**WOKINGHAM
BOROUGH COUNCIL**

Application Number: 242011

Site Address: Land east of Warren Lodge, Warren Lane, Finchampstead, RG40 4HR

MEMORANDUM

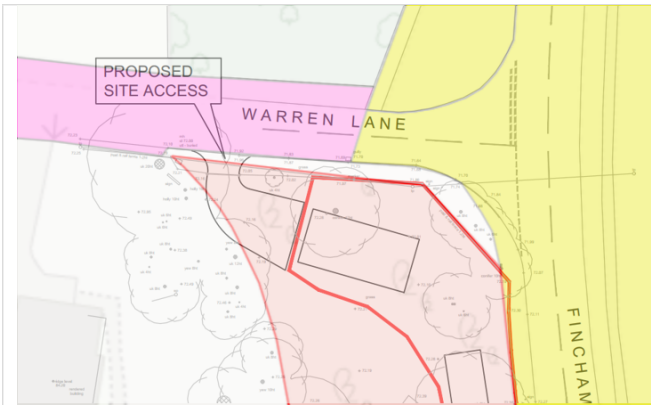
Meanwhile, as clarified, the northern access is included within the red line. However, the proposed red line does not connect with the public highways in yellow as shown below.

The applicant is expected to include all required land for the right of access to the site that is not part of public highways in the red line, serve notice to the landowner(s) on Warren Lane and to ensure have control on the land of the private road section of Warren Lane. If the red line does not revise to include reasonable right of vehicle access to the public highway, the Highways may recommend refusal to this applicant.

The PRow team shall be consulted for forming vehicular access along Warren Lane. The applicant shall consider the appropriateness of the proposed arrangements and to revise the red line if the northern access will be retained.
